**Stage 1 Road Safety Audit
Proposed Social Housing at
Craddockstown, Naas, Co. Kildare**

Document Control Sheet

Client:	Hayes Higgins Partnership
Document No:	240978-ORS-XX-XX-RP-TR-13g-001

Problem No.01: Overgrown Vegetation

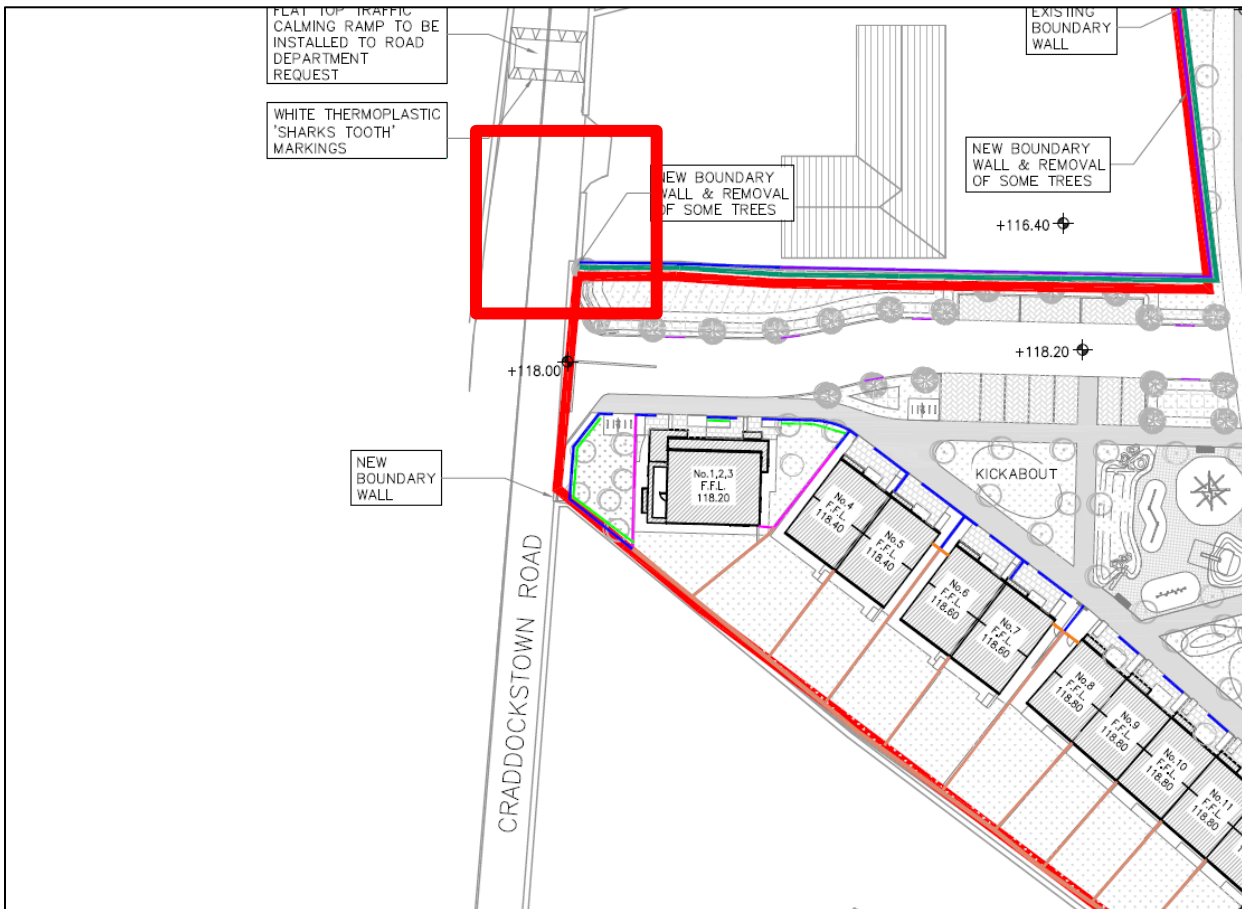
Location: Site Access/Egress Junction

The audit team observed during the site visit that overgrown vegetation along Craddockstown Road, where the proposed site access road is located, compromises visibility at the access junction. If the vegetation is not trimmed back, the line of sight for drivers and pedestrians exiting the proposed development may be obstructed, increasing the risk of accidents due to their inability to see approaching vehicles or pedestrians.

The design team should ensure that overgrown vegetation along Craddockstown Road is removed to establish and preserve clear sightlines at the proposed site access junction, ensuring safety for drivers and pedestrians.

Problem No.03: Absence of Speed Control Measures

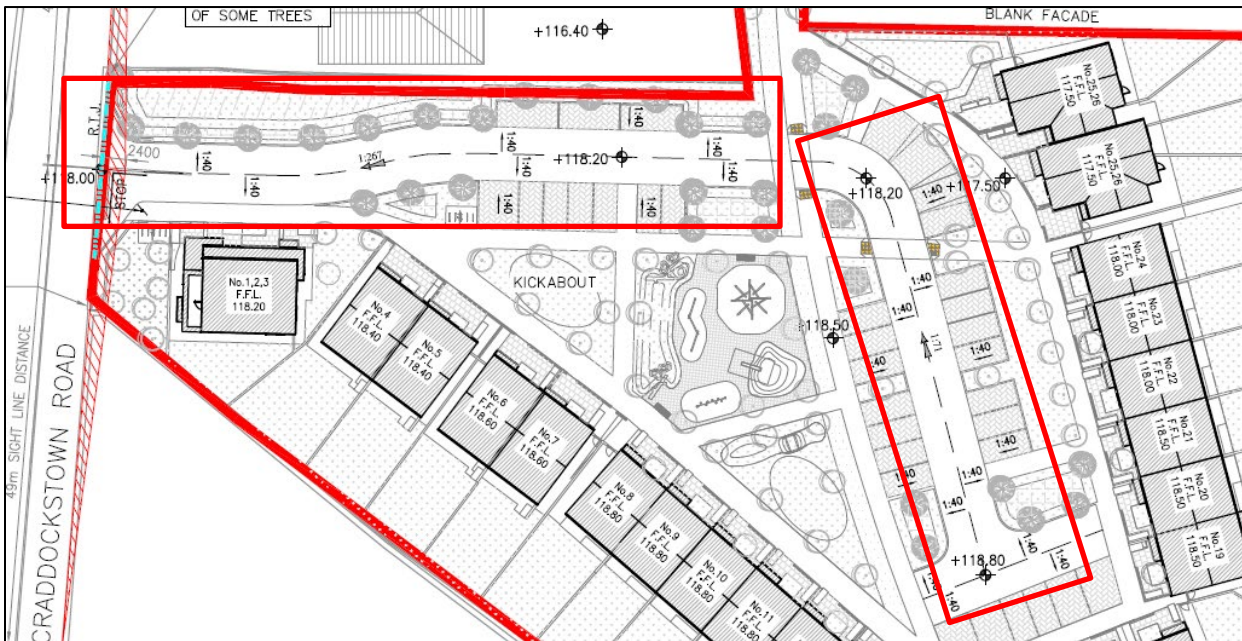
Location: Access Road

The audit team has observed from the provided drawings that there is no speed control measures along the length of the main access road. The lack of speed reduction features raises significant concerns regarding the potential for excessive vehicle speeds. This poses a heightened risk to vulnerable road users, such as pedestrians and cyclists, particularly in the event of a collision. The absence of adequate traffic calming infrastructure increases the likelihood of severe injuries among these road users, compromising overall safety within the development.

The design team should ensure that appropriate speed control measures are incorporated within the development to reduced vehicular speeds.

Problem No.04: Accessibility of Disabled Parking Spaces

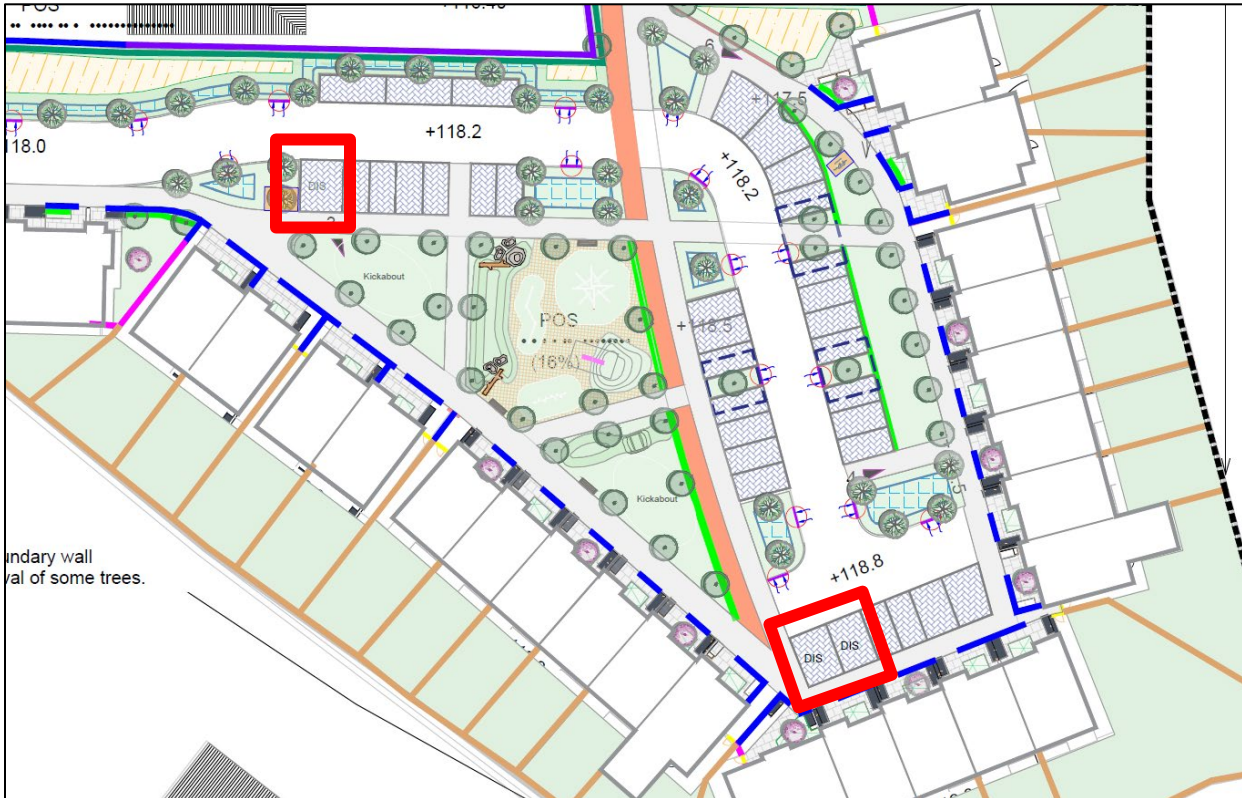
Location: Disabled Parking Spaces Identified

The audit team note from the drawings provided, that there is disabled parking spaces provided within development. It is not clear from the drawings provided if appropriate dropped kerbing is provided for these spaces at the locations identified below. The audit team are concerned that users of the spaces may not have access to the footpath and may use the closest road to access the footpath resulting in potential collisions between vehicles and vulnerable road users.

The design team should provide adequate provision for users of the spaces to access the footpath safely.

Problem No.05: Pedestrian Permeability

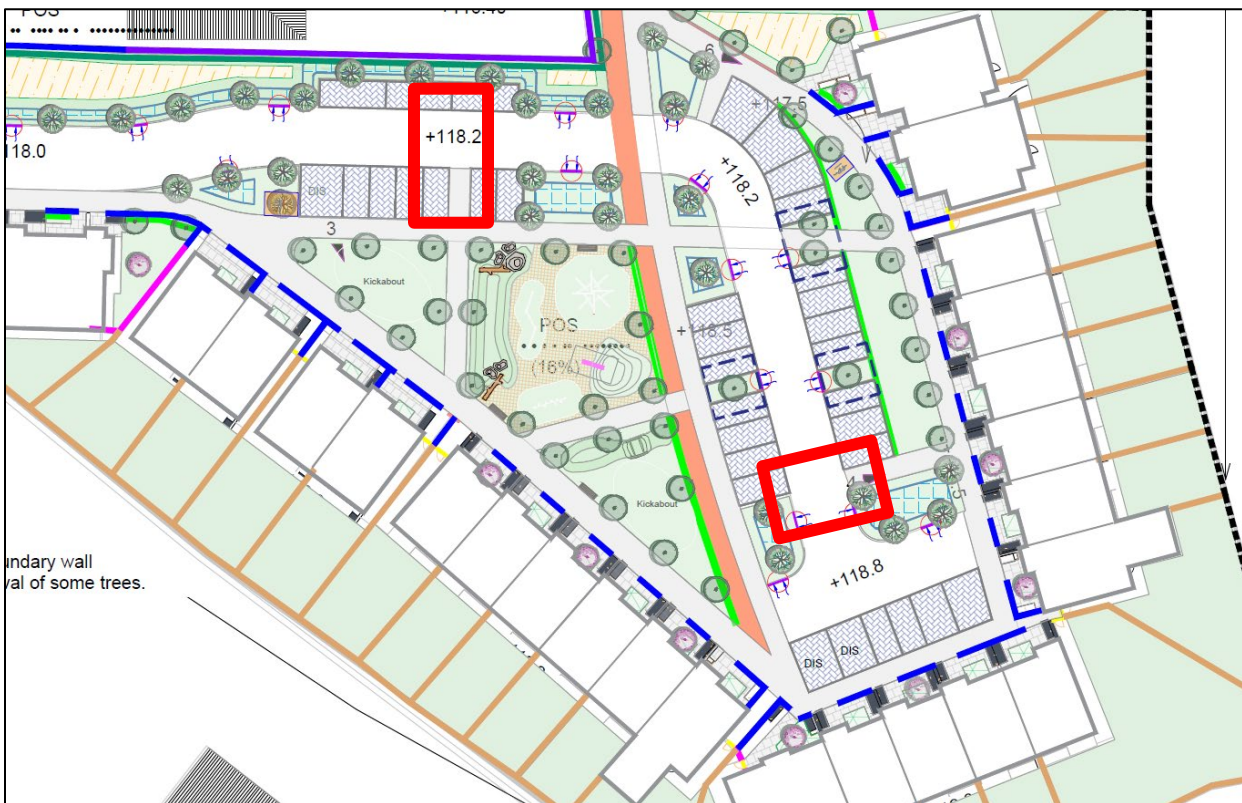
Location: Locations Identified

The audit team notes from the provided drawings that the proposed concrete footpath terminates at an opening onto the vehicular carriageway between two car parking bays. It is unclear from the drawings whether this opening is intended to serve as a pedestrian crossing, as there is no corresponding footpath on the opposite side. Therefore, the audit team finds no clear purpose for this footpath opening directly onto the carriageway. Furthermore, this design could be misinterpreted by pedestrians as a crossing point, potentially leading them to enter the carriageway without a safe route, thereby increasing the risk of pedestrian-vehicle conflicts. The audit team is also concerned about visibility at the crossing point due to the close proximity to the parked vehicles.

The design team should revise the footpaths at the locations identified if it is not intended to use the footpaths as a crossing location and ensure that appropriate visibility can be achieved at all crossing locations.

Problem No.06: Lack of Safe Crossing Infrastructure

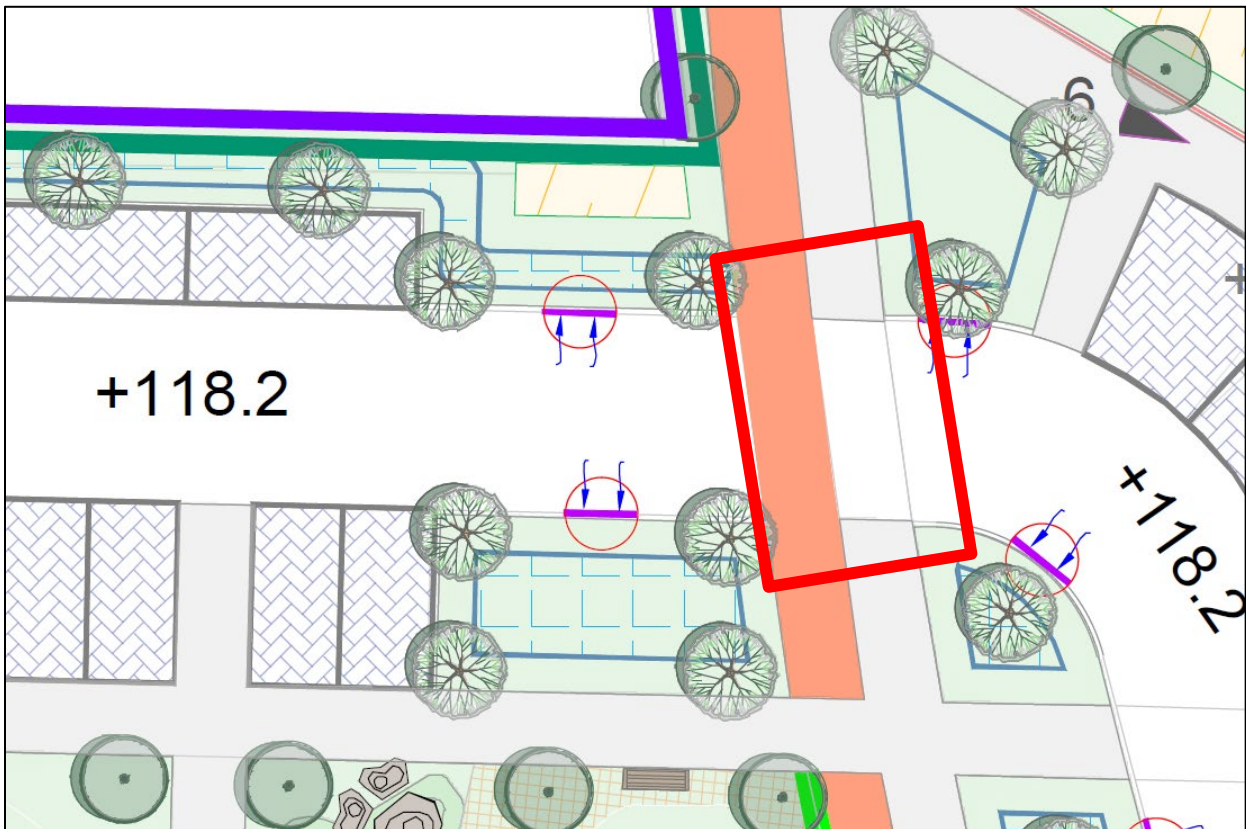
Location: Shared Pedestrian/Cycle Path on Vehicular Carriageway

The audit team notes from the provided drawings that the proposed Shared Pedestrian/Cycle Path intersects the vehicular carriageway without any controlled or uncontrolled crossing facility, appropriate warning signage, dropped kerbs or tactile paving. This design poses a significant safety risk, as pedestrians and cyclists may continue directly onto the carriageway without stopping, due to the absence of a designated crossing point. Without proper crossing infrastructure and warning signage, there is an increased likelihood of collisions between vehicles and pedestrians/cyclists.

The design team should ensure that this crossing location is appropriately designed including any raised areas, tactile paving and warning signage.

Problem No.07: Cycle Path/Footpath Intersection

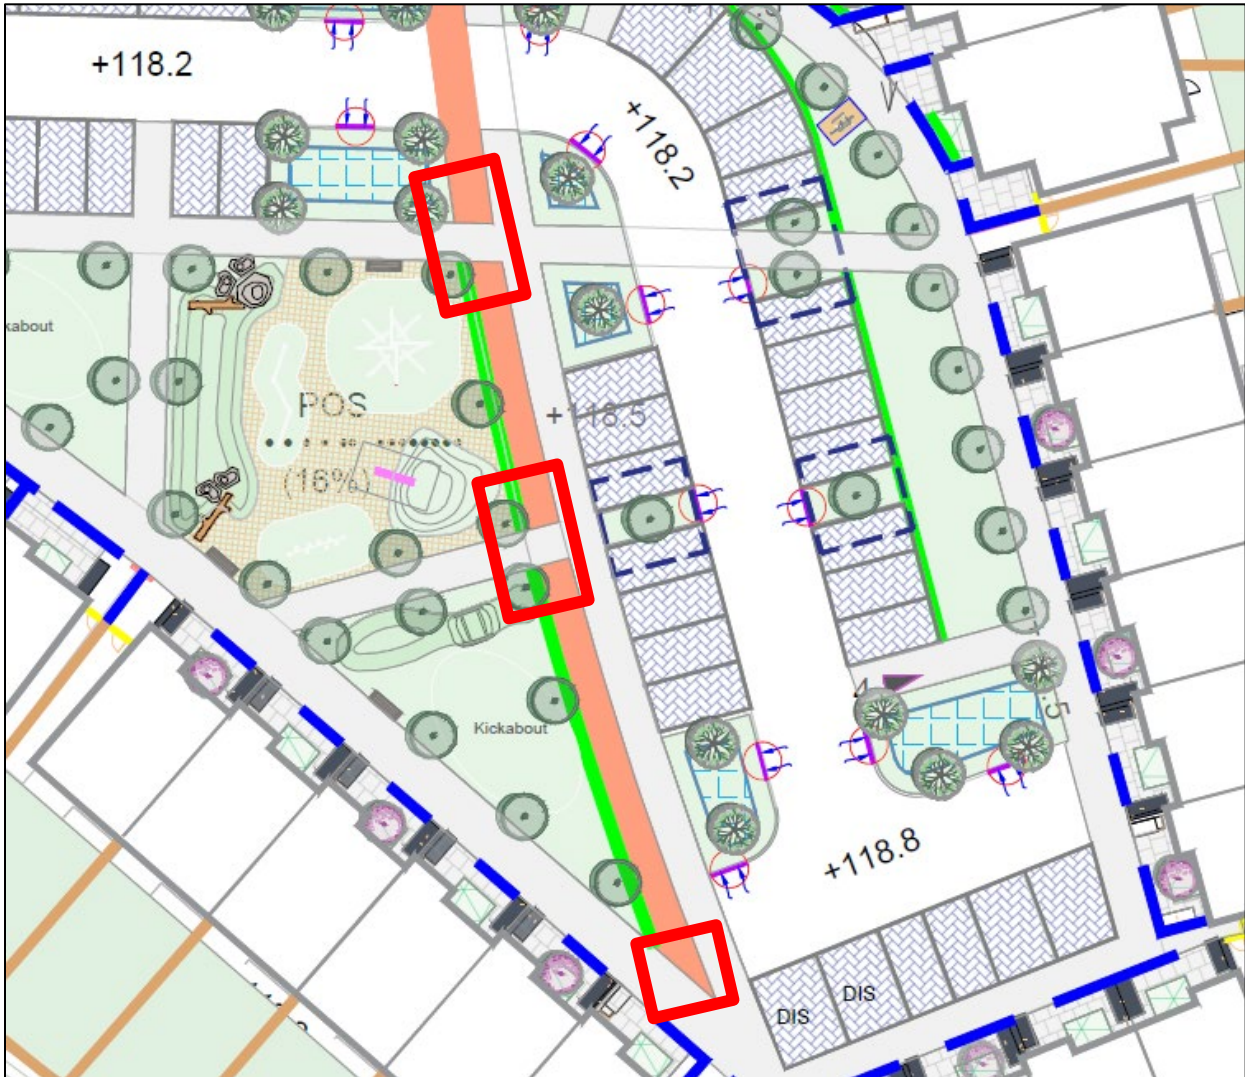
Location: Locations Identified

The audit team notes from the provided drawings that the proposed cycle path crosses over the footpath at the locations identified. The Cycle Path intersects the footpath without any controlled or uncontrolled crossing facility, appropriate warning signage or tactile paving. This design poses a safety risk, to pedestrians as cyclists may continue directly onto the footpath without stopping, due to the absence of any warning.

The design team should ensure that this crossing locations is appropriately designed including any tactile paving and warning signage.

Problem No.08: Tie-in to Existing Cycle Path/Footpath

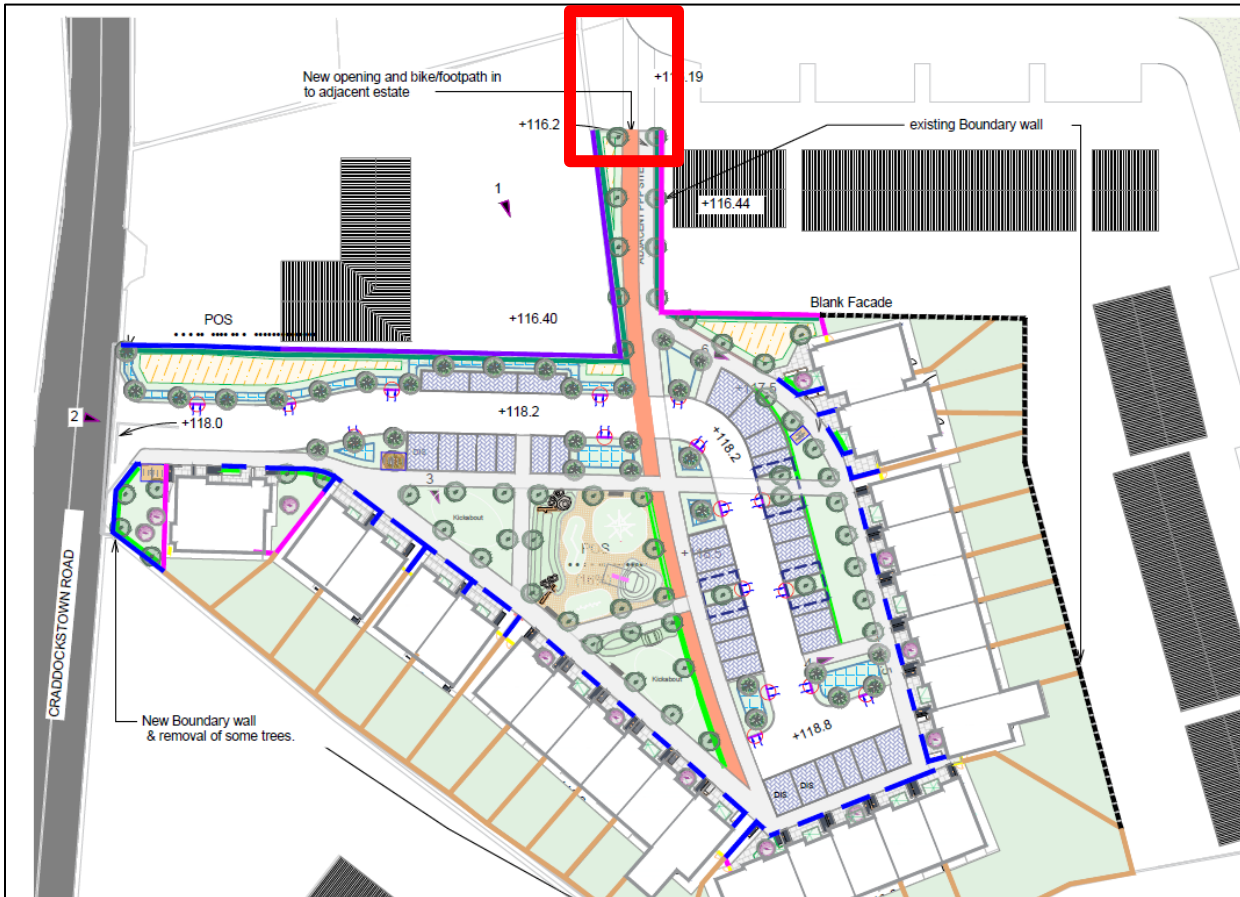
Location: Location Identified

The audit team note from the drawings provided that there are no details of the existing infrastructure that the scheme ties into at the location identified. Lack of an appropriate tie-in to the existing cycle path/footpath could lead to cyclists, pedestrians discharging into inappropriate infrastructure.

The design team should provide appropriate details at the tie in location and any associated signage, markings and tactile paving.

Problem No.09: Manholes on Cycleway Crossing

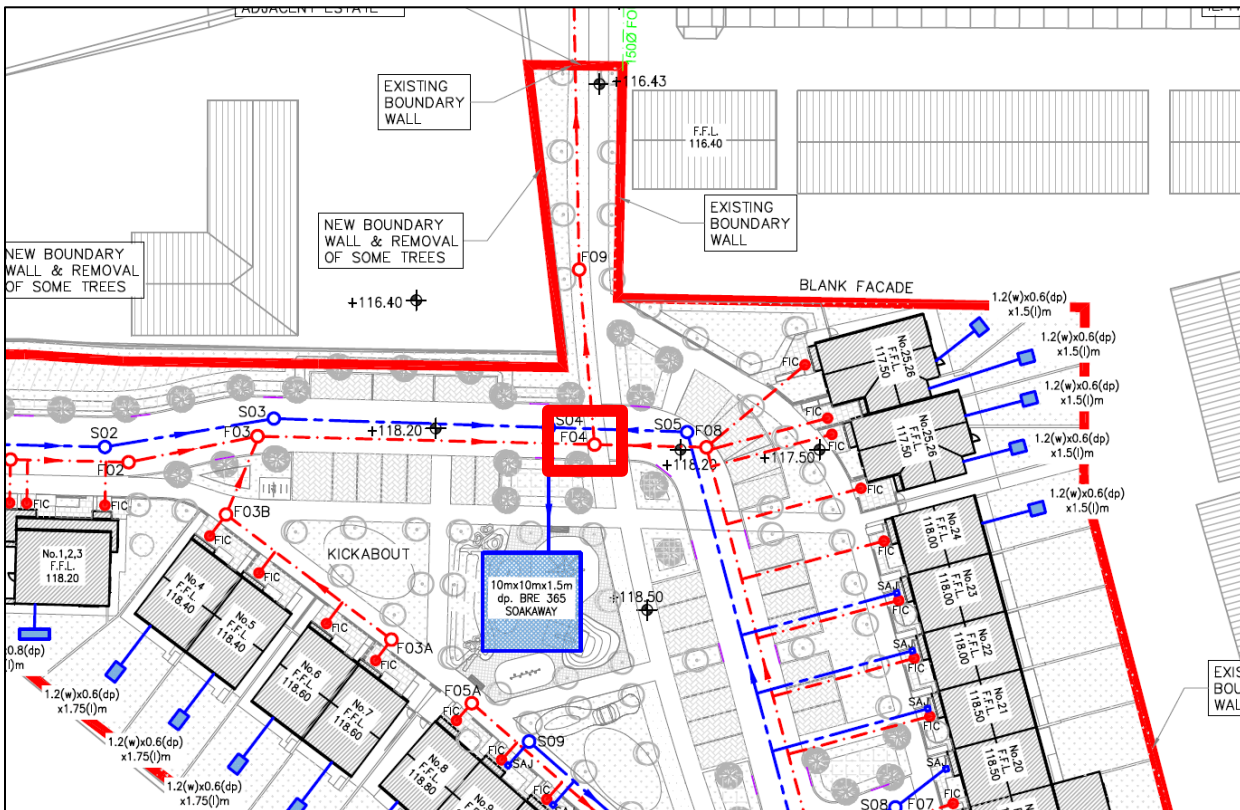
Location: Location Identified

The audit team has observed from the provided drawings that proposed surface water and foul water manholes are located on the cycle path surface on the crossing at the location identified. If these manholes are not flush with the footpath or if their surfaces are uneven, they pose a significant tripping hazard for cyclists, particularly in wet conditions. This misalignment can lead to increasing the risk of falls and injuries to cyclists on the crossing.

The design team should ensure that all manholes are installed flush with the surrounding footpath surface and apply a non-slip surface treatment on the manholes to enhance traction for cyclists, particularly in wet conditions.
